RE: 150 Steeles Avenue East and 248, 250 & 314 Martin Street, Milton, Proposed Mixed-Use Development

This memorandum is intended to provide additional information to address the Town’s transportation-related comments dated April 2, 2026 and April 8, 2026, and the Region’s transportation comments dated April 17, 2026, in regard to BA Group’s February 2026 Transportation Considerations Report (“the February 2026 BA Group Report”). We trust that the enclosed memorandum provides the appropriate information requested by the Town. Please feel free to let us know if you have any questions or require any additional information.

1.0 BA GROUP RESPONSES TO TOWN COMMENTS

OUTBOUND

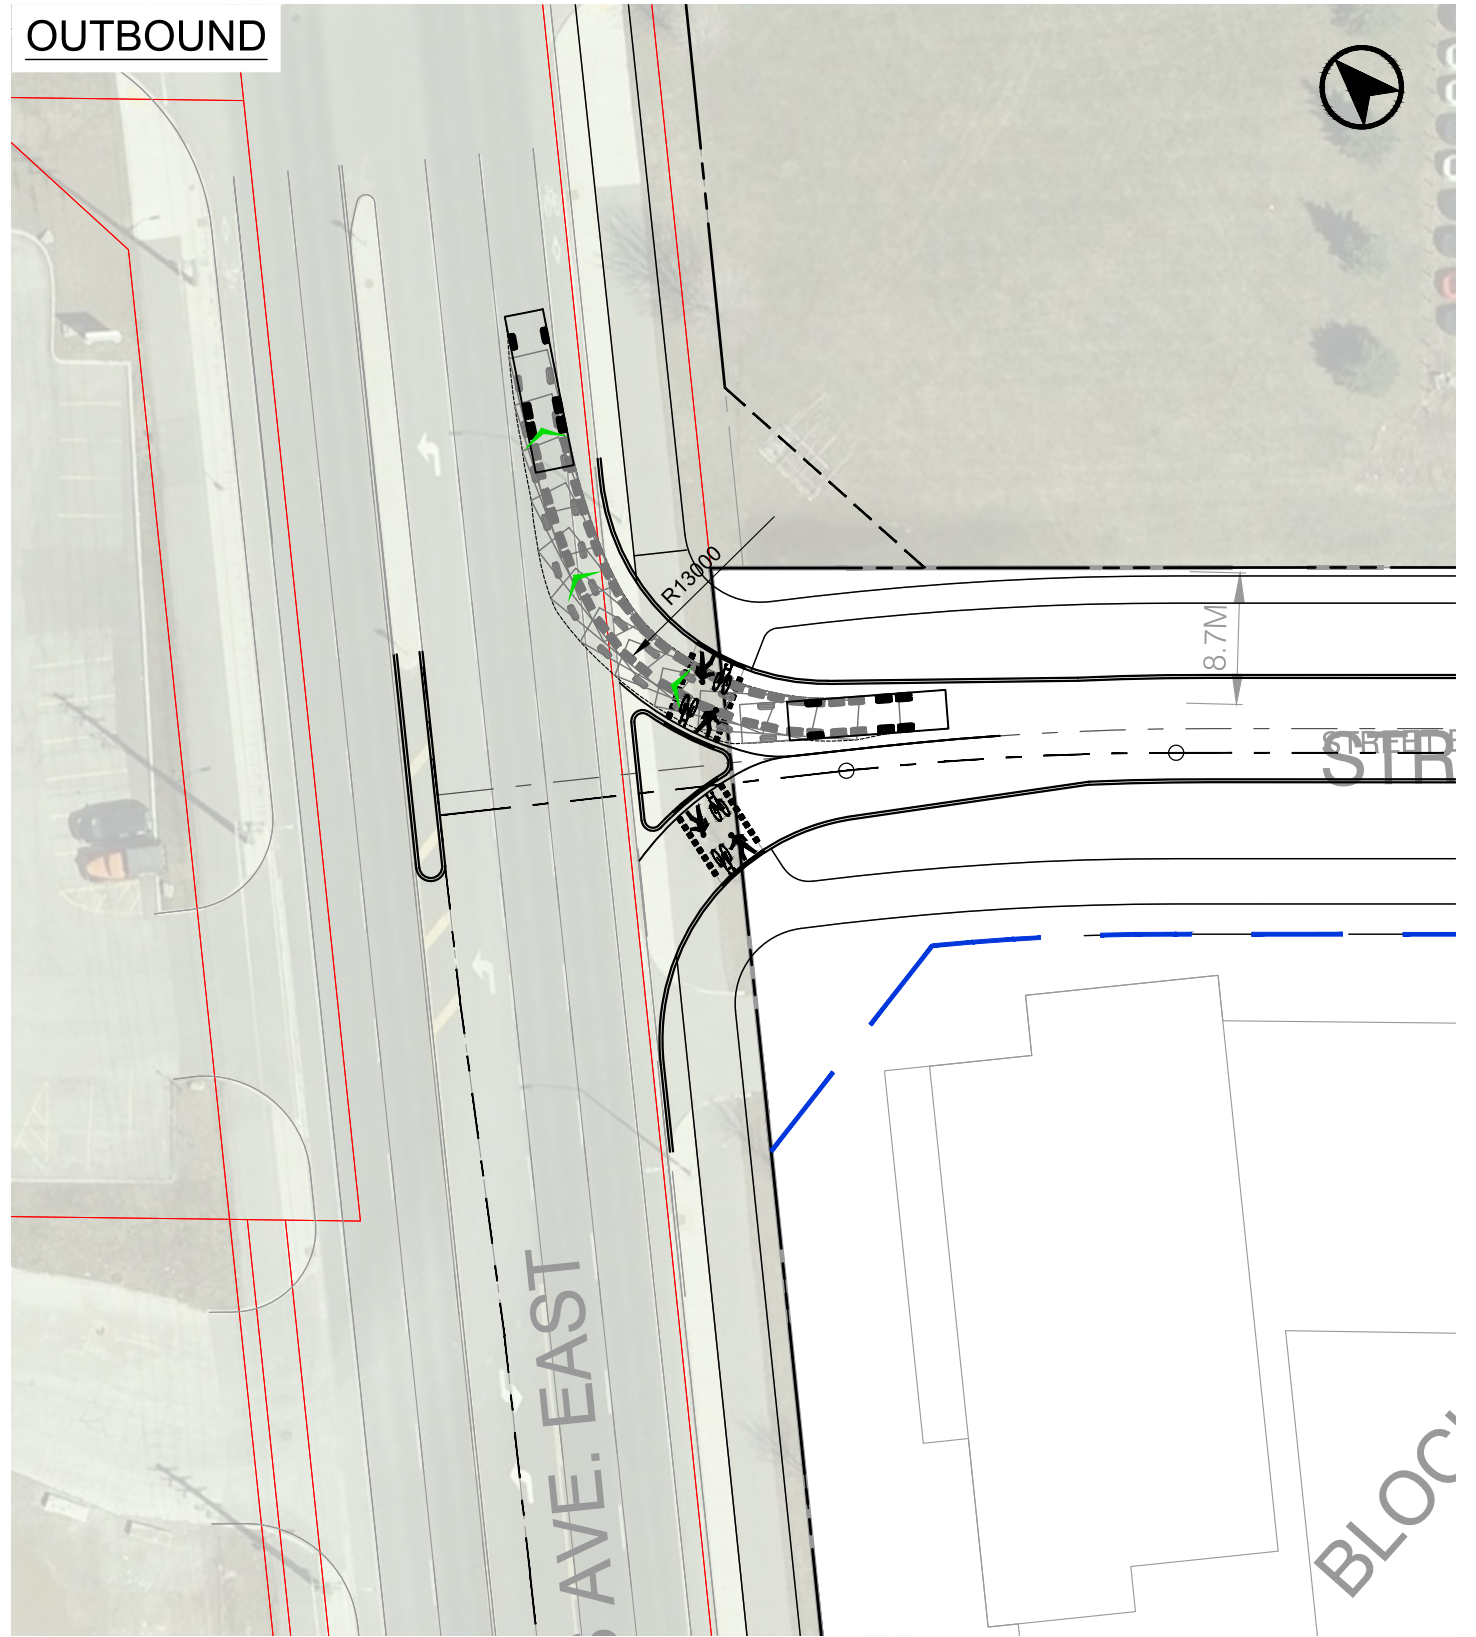
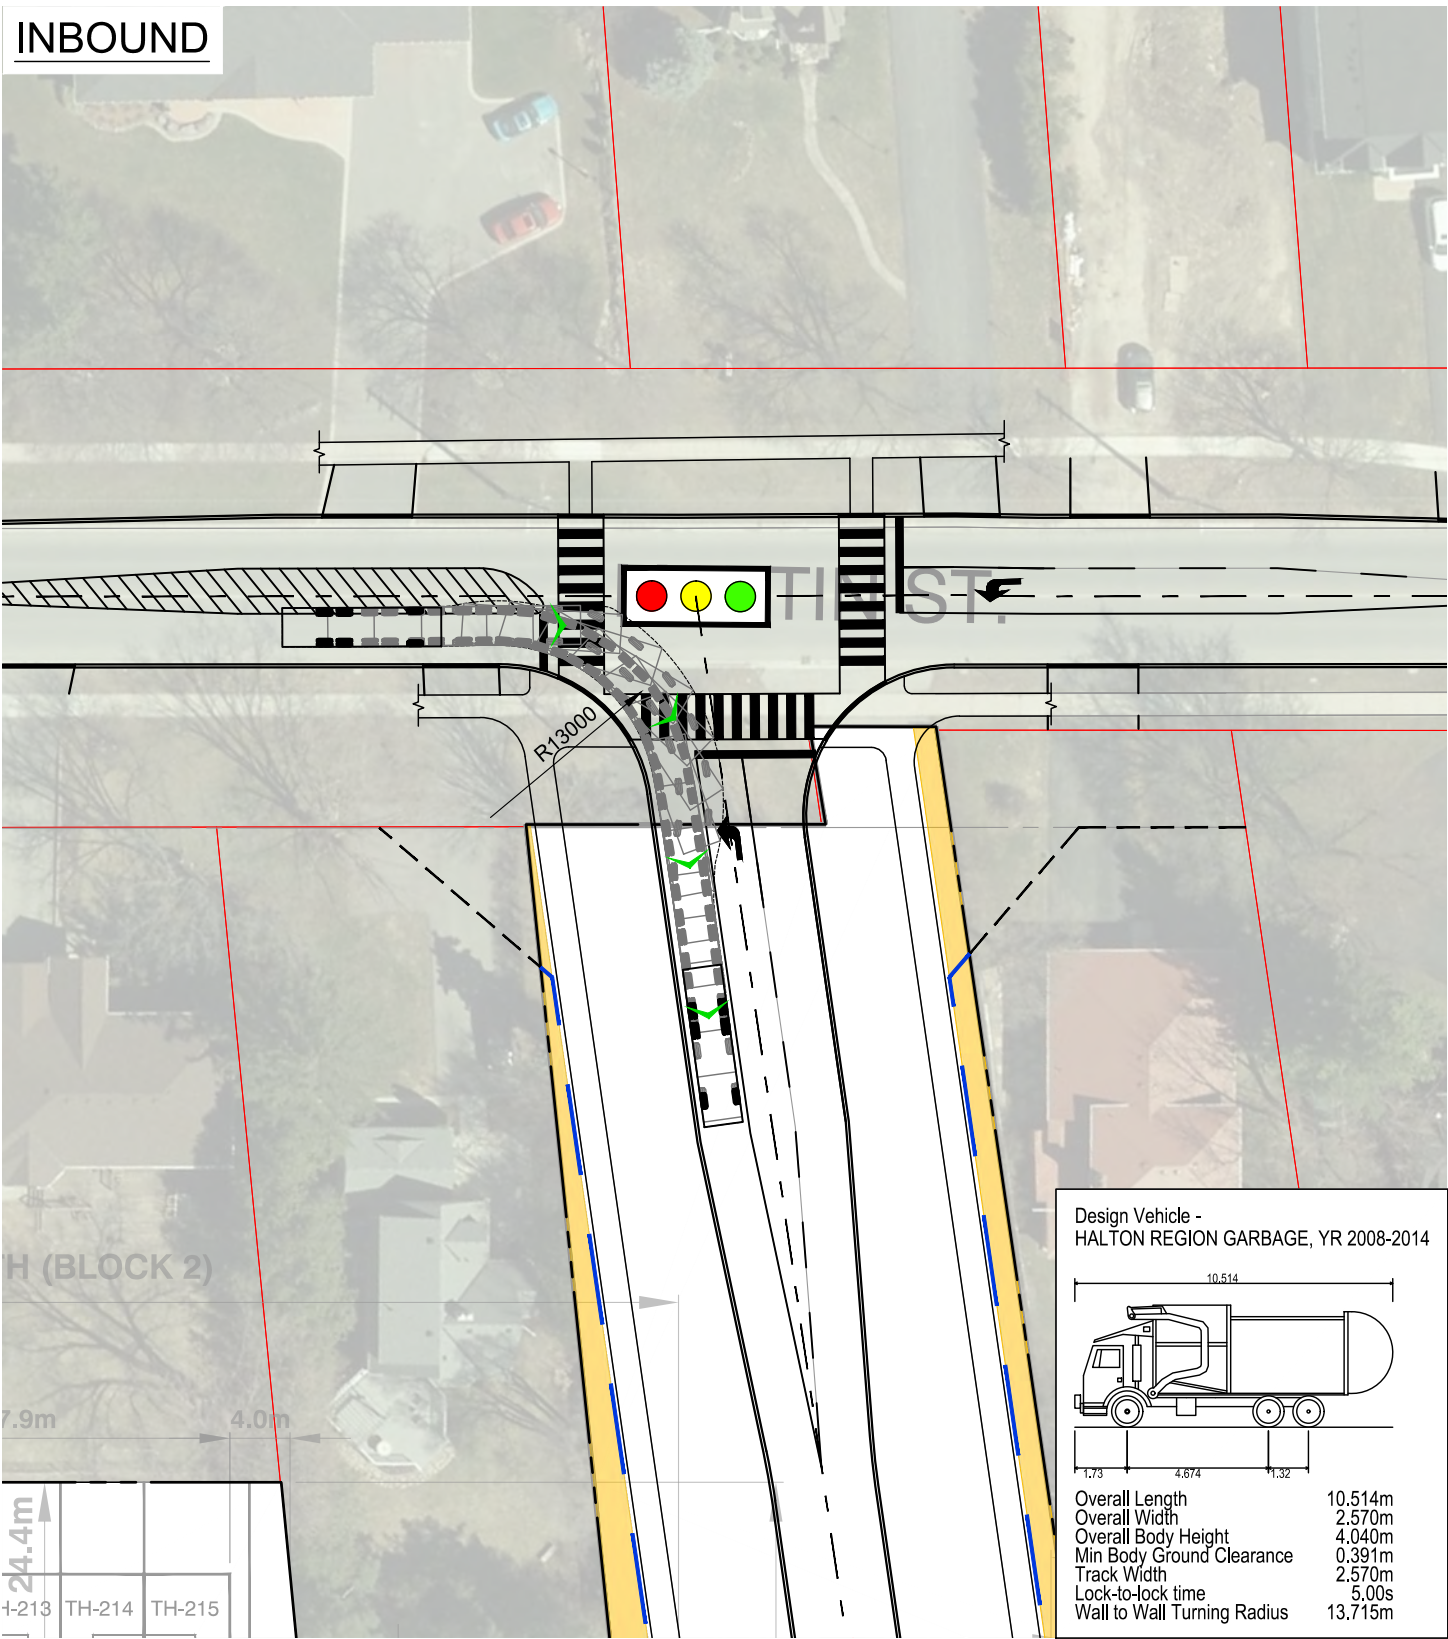
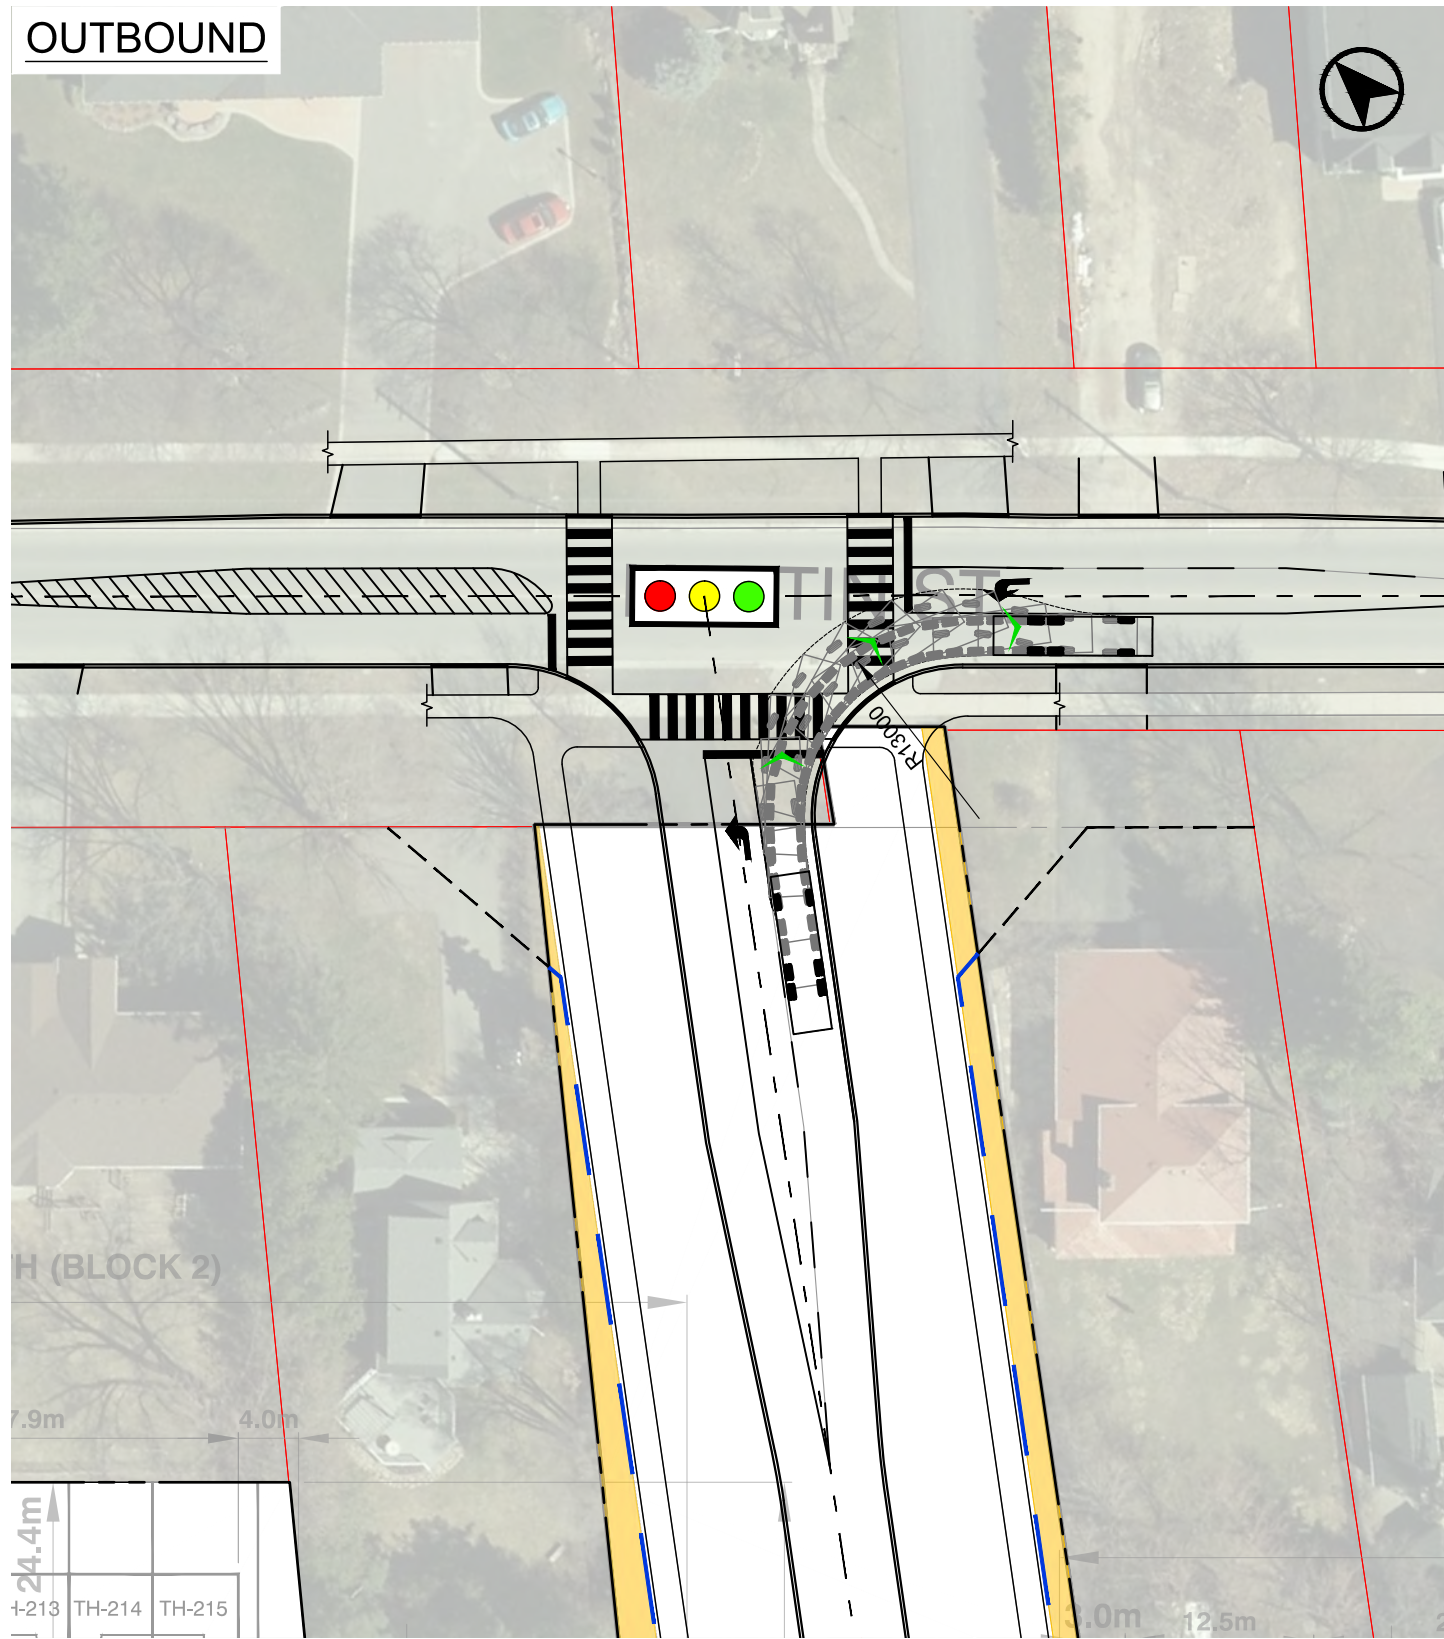
Comment: Please indicate the centreline turning radius in all locations where the waste collection vehicle is turning and approaching loading area (minimum 13 metres).

Comment: Please indicate the length of the head-on approach (minimum 18 metres).

Comment: Please indicate the distance the waste collection vehicle will be required to reverse (maximum 18 metres).

Comment: Please indicate the waste collection vehicle route from the municipal road to the Collection Point and back to the municipal road. Please ensure to include the turning radius of all turns.

Comment: Where continuous forward movement of waste truck cannot be achieved, a cul-de-sac or T-turnaround may be permitted if 13m turning radius and max 18 metre backup distances can be met.

Comment: Notwithstanding the loading requirements set out in the Town 's Zoning By-law, the loading spaces in Phase 1 of the development are proposed to be 12 m x 3.5 m (overhead waste collection) in size.

- All dimensions on the below loading areas including centre line turning radii.
- One truck maneuvering diagram. The overlay provided below makes it difficult to determine the path of the collection vehicle.

Response: The centreline turning radius of a minimum of 13 metres is illustrated on the Vehicle Manoeuvring Diagrams (VMDs) attached in **Appendix C**.

Response: The 18 metres head-on approach is illustrated on the VMDs attached in **Appendix C**.

Response: The reversal distance of the waste collection vehicle is illustrated on the VMDs attached in **Appendix C** and illustrate reversal distances of 18 metres or less.

Response: VMDs provided in **Appendix C** illustrate waste collection vehicles entering each block from the municipal road and leaving each block onto the municipal road.

Response: VMDs provided in **Appendix C** illustrate waste collection vehicles entering and existing each site in a forward motion. The turning radius (minimum 13 metres) and the reversal distances (maximum 18 metres) are illustrated on the VMDs.

Response: Vehicle Manoeuvring Diagrams provided in **Appendix C** illustrate the waste collection vehicle entering and exiting the proposed waste collection areas with dimensions (minimum 13 metres turning radius, minimum 18 metres head-on approach and maximum 18 metres reversal distance).
